Project Number: SP2018-007
Project Name: Starbucks
Project Type: SITE PLAN
Applicant Name: MOORE WORTH INVESTMENTS, LLC
Owner Name: MOORE WORTH INVESTMENTS, LLC
Project Description:

City of Rockwall Project Plan Review History

Project Number SP2018-007	Owner MOORE WORTH INVESTMENTS, LLC	Applied 3/13/2018 LM
Project Name Starbucks	Applicant MOORE WORTH INVESTMENTS, LLC	Approved
Type SITE PLAN		Closed
Subtype		Expired
Status Staff Review		Status

**CITY OF ROCKWALL
PLANNING AND ZONING COMMISSION MEMO**

SITE PLAN
LAKESHORE COMMONS
LOT 3; LAKESHORE COMMONS
ROCKWALL, ROCKWALL COUNTY, TEXAS
MOORE WORTH INVESTMENTS, LLC
8445 FREEMONT PARKWAY, SUITE 175
IRVING, TX 75063
214-415-9993

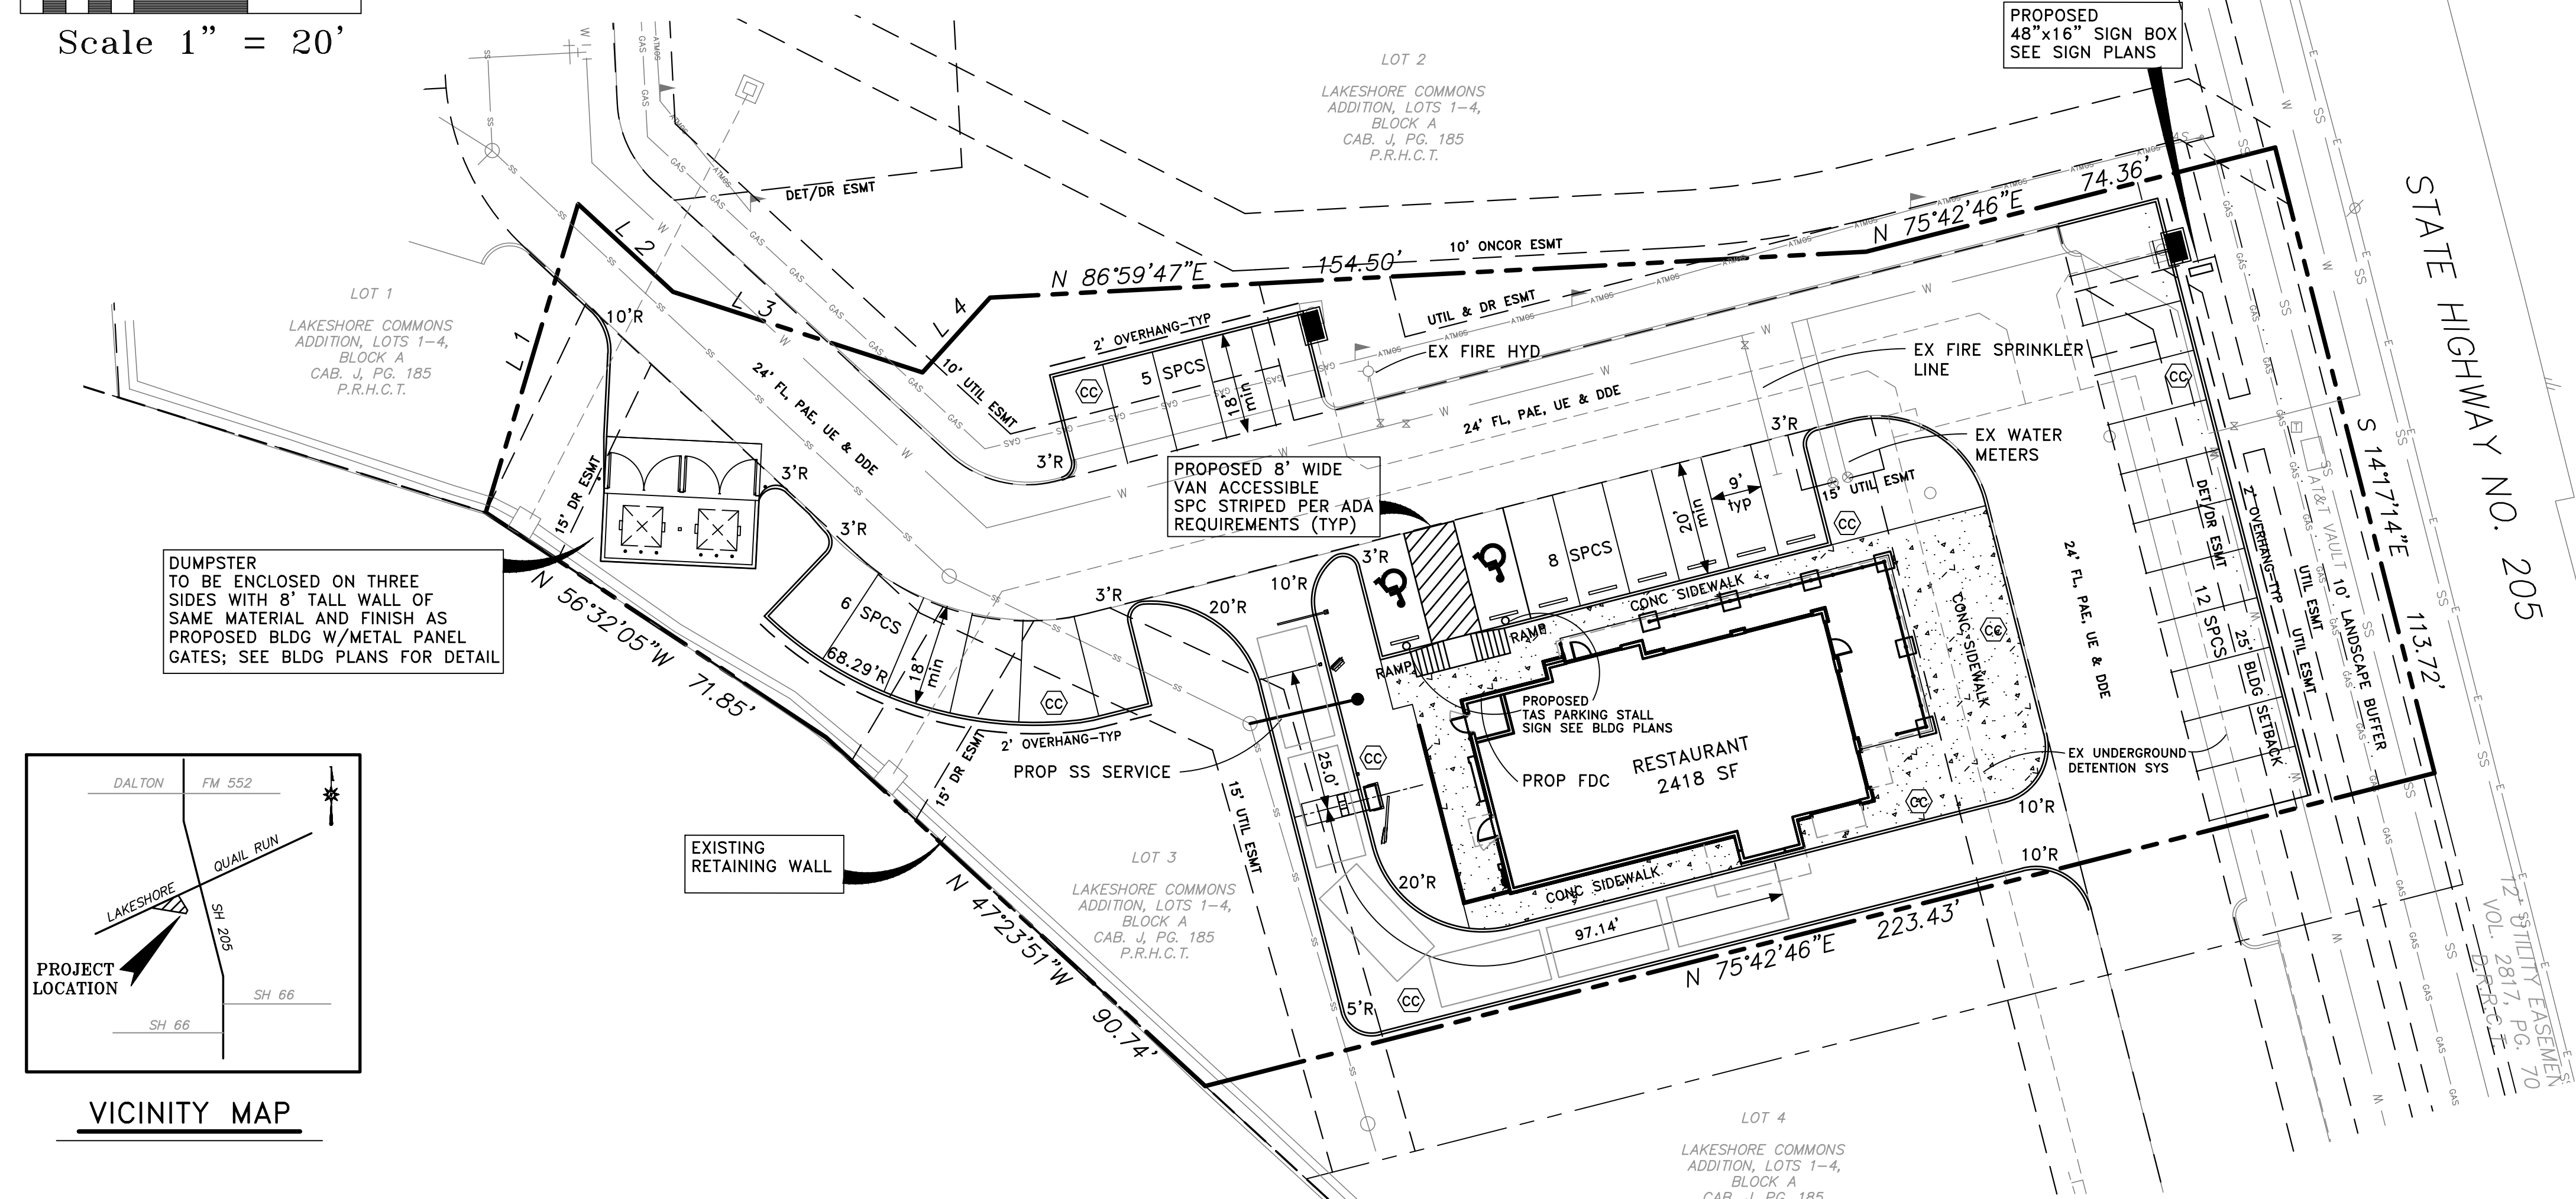
Type of Review / Notes	Contact	Sent	Due	Received	Elapsed	Status	Remarks
BUILDING	John Ankrum	3/13/2018	3/20/2018	3/19/2018	6	APPROVED	
ENGINEERING (3/21/2018 9:47 AM SH) See markups Parking spaces not facing the building must be 18' by 9' wide at the smallest point. The fireline min. interior curb radius is 20'. Why does the curb terminate in the northeast corner of the site? 4% Engineering Inspection Fees Impact Fees Dumpster area to drain to oil/water separator or grease trap Show and label flood plain with cross sections and elevations Signage can't be in an easement or right-of-way Engineering plans will not be approved until the Lakeshore Commons infrastructure has been finished and accepted by the City Show that all shrubs planted adjacent to 18' parking spaces to be planted 4' from back of curb	Amy Williams	3/13/2018	3/20/2018	3/21/2018	8	COMMENTS	See Comments
FIRE	Ariana Hargrove	3/13/2018	3/20/2018	3/23/2018	10	APPROVED

I.4						This property will be required to be plated prior to the issuance of a building permit.
M.5						Please note that this site is situated in the North SH-205 Overlay District. Please review those standards, specifically for landscaping. Please include the overlay district in the site summary table of each page.
M.6						Site Plan. Please provide floor area ratio in site summary table of each page.
M.7						Site Plan. The restaurant shows 2,418 SF, but the site summary table shows 2,200 SF. Please provide the correct SF.
M.8						Site Plan. Dumpsters cannot face the street.
M.9						Site Plan. No structures in any easements. The dumpsters seem to clip an easement.
M.10						Site Plan. Please provide width (at the smallest point) for the 6 parking spaces adjacent to the dumpsters.
M.11						Site Plan. Please provide the radio for the curb on the east side of the row of parking that includes the accessible spaces. (Where it says "EX Water Meters" and "15' Utility Easement").

M.12						Site Plan. Please dimension all walls of the building.
M.13						Site Plan. Please show distance from the property line to the building for each side.
M.14						Site Plan. Please note that the LS buffer is 20-feet not 10-feet as indicated on the site plan (unless you are requesting a variance).
M.15						Site Plan. There seems to be a patio on the north and east side of the building. Will outdoor seating be provided?
M.16						Site Plan. Please provide paving material and thickness.
M.17						Site Plan. Please show centerline of SH-205.
M.18						Landscape Plan. Please provide the same Site Data Table as provided on the Site Plan.
M.19						Landscape Plan. Dumpster seems to encroach easement.
M.20						Landscape Plan. Please note that no parking space shall be more than 80-feet from a canopy tree. Please provide 80-foot buffers to ensure coverage.
M.21						Landscape Plan. Please note that in the overlay district the landscaping requirement is 2 canopy trees and 4 accent trees per 100-feet.

LANDSCAPE PLAN

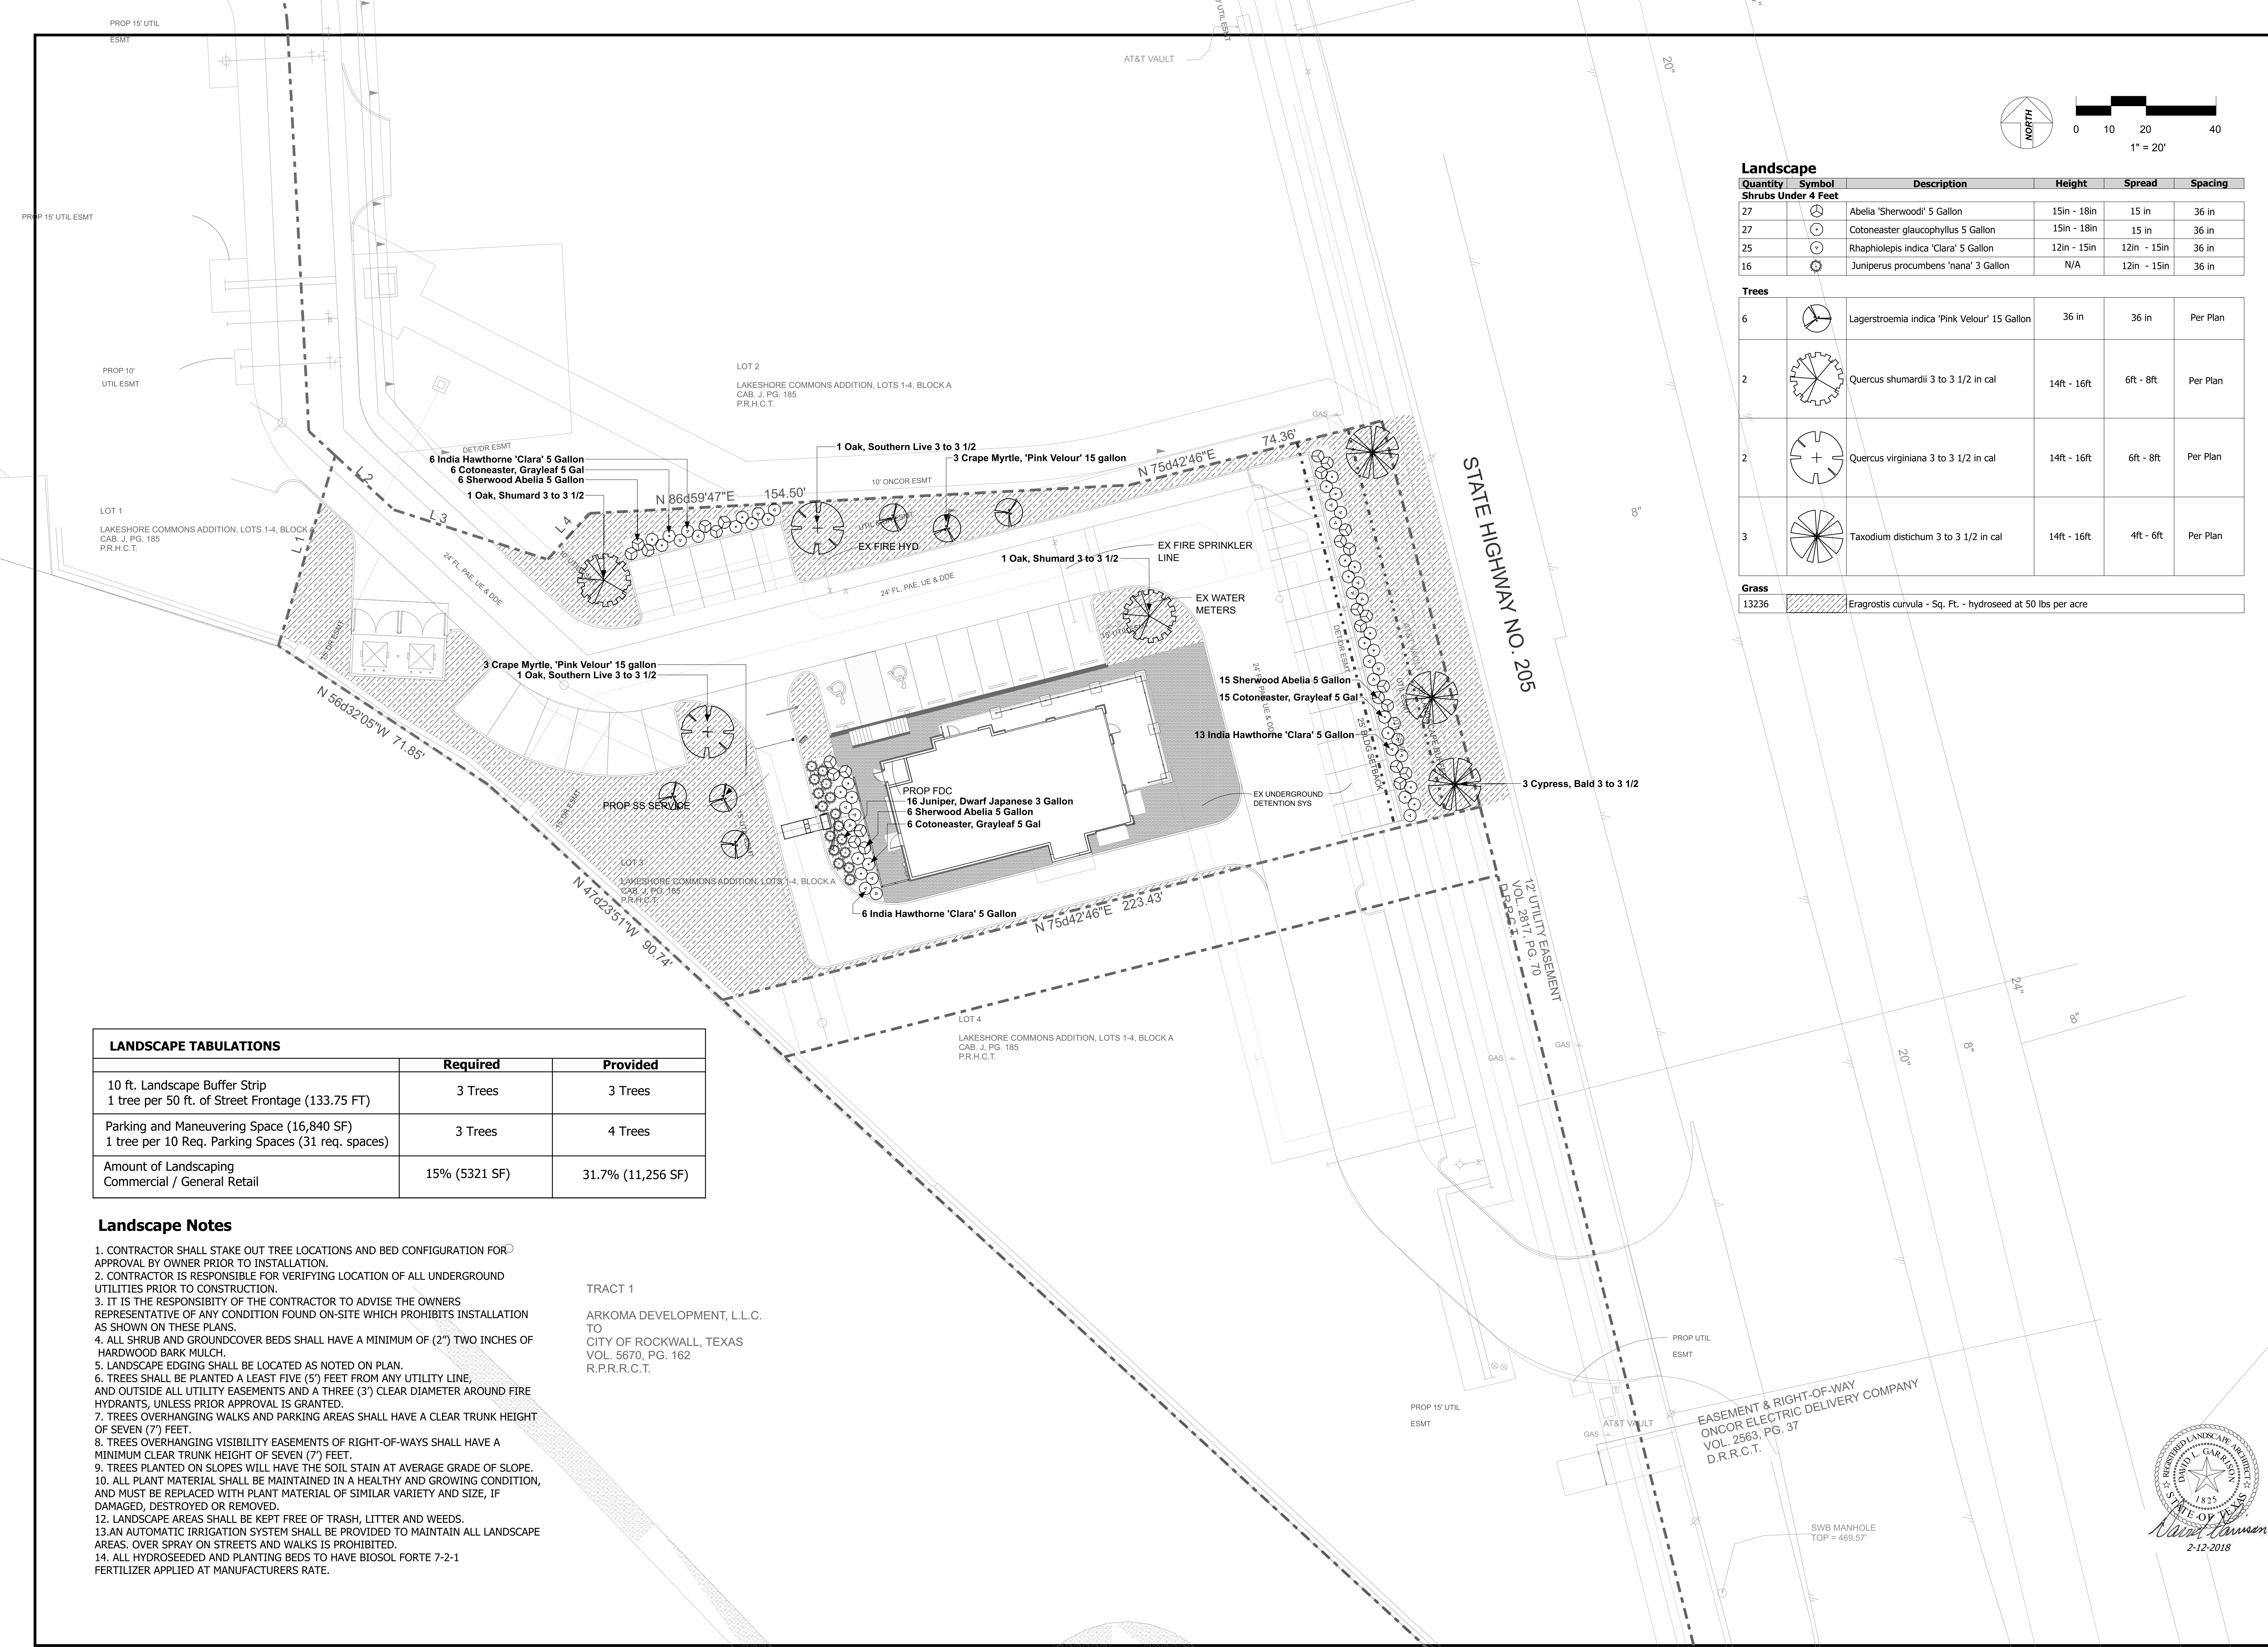
M.22						Landscape Plan. Please note that canopy trees are a min of 4 caliper-inches and not 3-3.5 caliper-inches as shown.
M.23						Landscape Plan. Please note that the LS buffer is 20-feet not 10-feet.
M.24						Photometric Plan. Please darken property line on photometric plan.
M.25						Photometric Plan. Please provide some clarification on the symbols for "Egress 1, 2, 3, and Property Line"
M.26						Photometric Plan. Please label cut sheet so that I can determine which cut sheet matches the fixture type on the photometric plan.
M.27						Photometric Plan. Please note that any light over 15-watts shall be directed downward with a partial or full cutoff
M.28						Photometric Plan. Please provide site data table as shown in site plan.
M.29						Photometric Plan. Please show centerline of SH-205
M.30						Building Elevations. Please note that the overlay district requires 8-foot dumpster enclosure. Please provide elevations of dumpster enclosure.
